TITLE: Product Technical Bulletin – PTB112614
DATE: December 8, 2014
SUBJECT: Converting **puraDYN**® PFT & TF Bypass Systems to use Polydry Filters

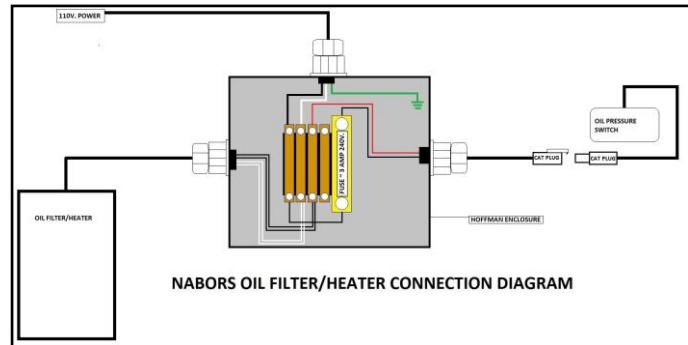
Disconnect the wire leads routed to the engine. Typically the 110V wire leads run from the junction box (ex. Hoffman Enclosure) to the engine - **see diagram**.

Make sure the engine power source or electrical panel (from where the 110V lead was plugged) is returned to its original OEM specification. No exposed wires should be present. Verify no power is going to the electrical junction box or TF/PFT Unit before reconnecting the power.

3. **(A) Removing the heating element from TF Lid:**

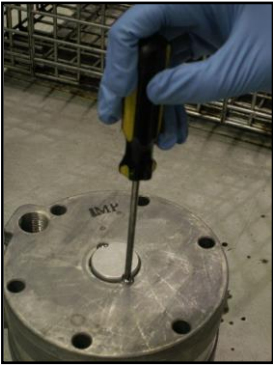
The heating element is located top dead center of the Lid.

Using a Philips screwdriver, unscrew the two heater cover screws. Remove Heater Cover from the TF Lid, being careful not to lose the 2 screws as they will be needed later to reinstall the heater cover.

Remove the heating element from the Unit by pulling up on the steel shroud. The heating element should slide out with minimal force.

After the heating element has been removed, place the heater cover back on the TF Lid. Position screws in place and tighten heater cover screws down with 12 in-lbs. A small amount of Loctite can be applied to prevent the screws from vibrating loose in the future.

3. (B) Removing the heating element from PFT Diffuser:

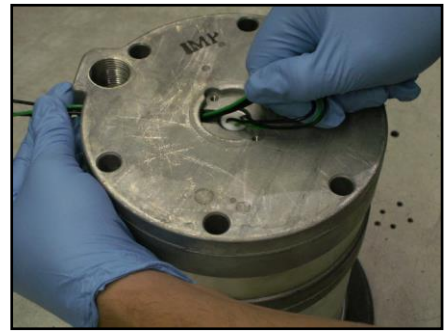
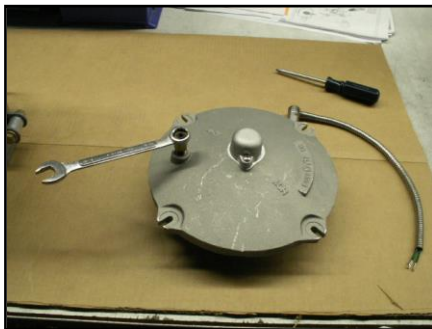
Using a Philips screwdriver, unscrew the two heater cover screws. Remove the heater cover, being careful not to lose the 2 washers and screws.

With one hand grab and "push" the wire through the channel. This may require a screwdriver to leverage the wires up before pulling wires by hand. Be careful not to scar the wire insulators.

Next, pull the wires out of the channel and remove the heating element from the Unit by pulling up on the wires. The heating element should slide out with minimal force.

After the heating element has been removed, place the heater cover back on the diffuser. Position Lock washers in place and screw heater cap screws down with 12 lbs. A small amount of Loctite can be applied to prevent the screws from vibrating loose in the future.
